Design Review Committee Meeting

Item # 3.1 Design Review No. 5156

Agenda Name	Comments	Support	Oppose	Neutral
2. PUBLIC COMMENTS	1	0	1	0
3.1. A request to demolish the existing structures and construct a new single-family residence and detached garage at 405 E. Toluca Avenue. (Design Review No. 5156).	2	0	0	2

End of Toluca Avenue

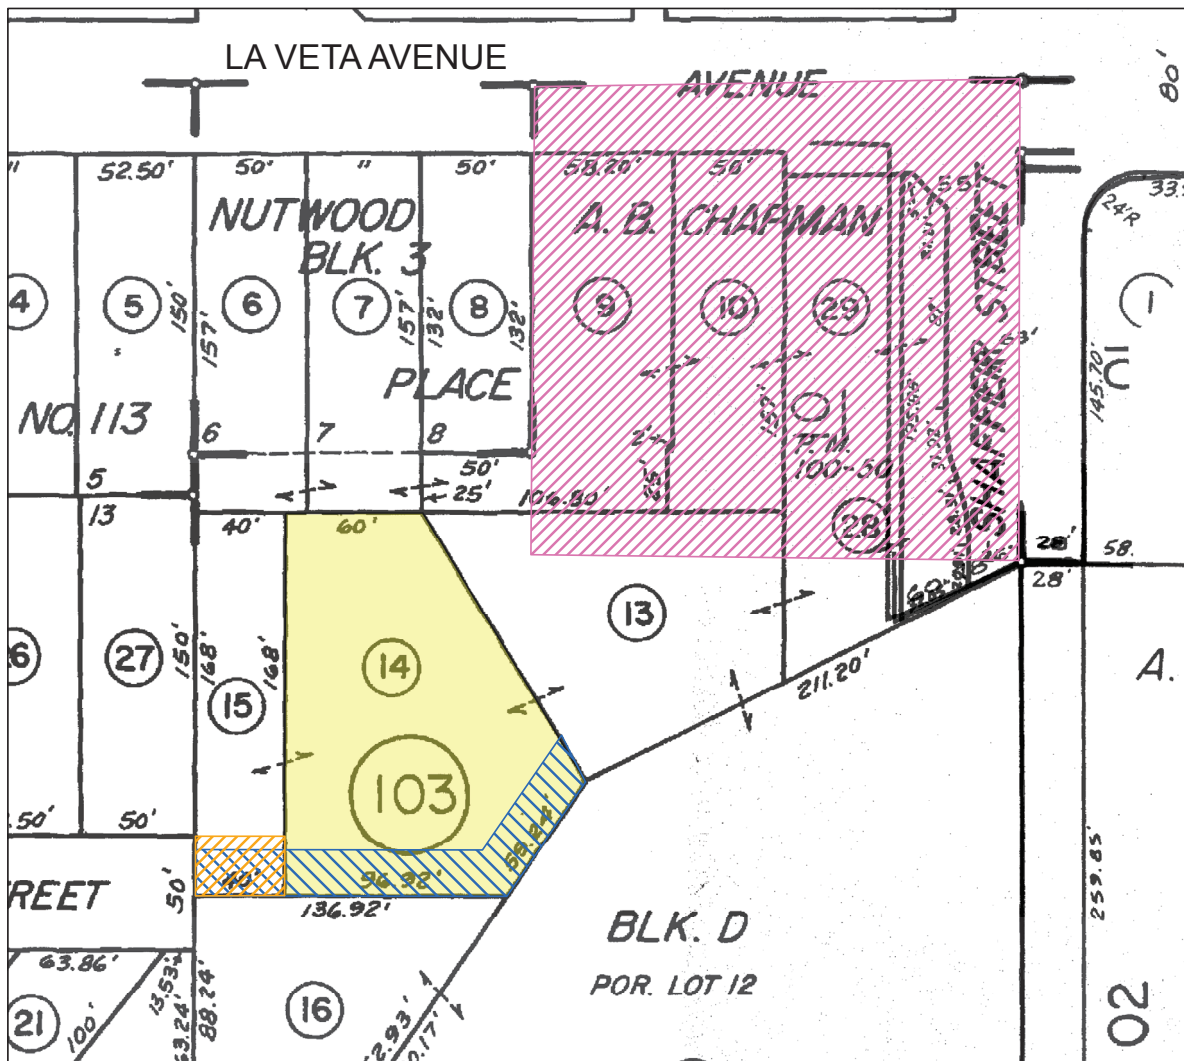
Toluca Avenue is a sub-standard street that only allows for parking on one side of the street, and dead ends into the shared driveway for 415 and 435. As the street is currently constructed, anytime there is a delivery truck, or a car parked on the wrong side of the street, or a trash truck, it blocks access to the street. I have attached a picture of the existing end of street so you can see the challenges it poses.

If the sidewalk is constructed, it would be incredibly challenging to turn a car around at the end of the street. It would also make accessing our driveway more challenging, and would impede the existing easement. Additionally, there is no information on how the sidewalk would terminate, since the plans are not correct (see more details on that below), and the sidewalk and curb would abut an existing block wall.

We request that the sidewalk extension not be included in the project, since it impedes our easement, and creates unsafe conditions on the street by narrowing the end of the street with no turnaround. Improvements should be further reviewed in conjunction with Public Works to ensure that all deed restrictions are complied with prior to issuance of any demolition or construction permits within the easement area.
